Re: [FACILITY]

This Report will discuss the research, analysis, calculations, opinions, and conclusions of USA Management LLC. concerning the existing aquatic facilities at [FACILITY] Swimming Pool Facility located at [FACILITY ADDRESS].

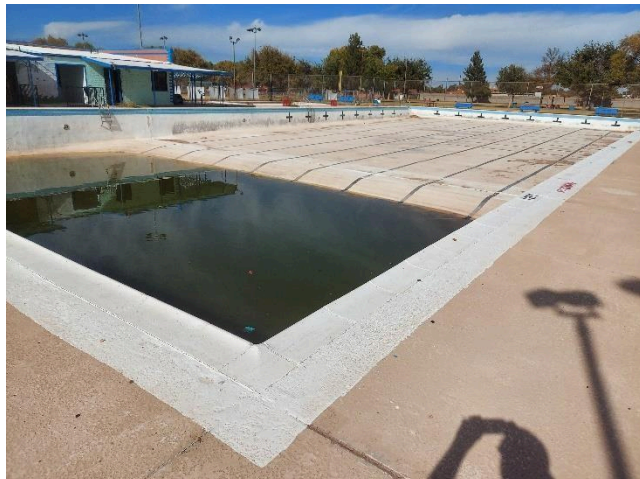
Chain link perimeter fence and exterior pole lighting.
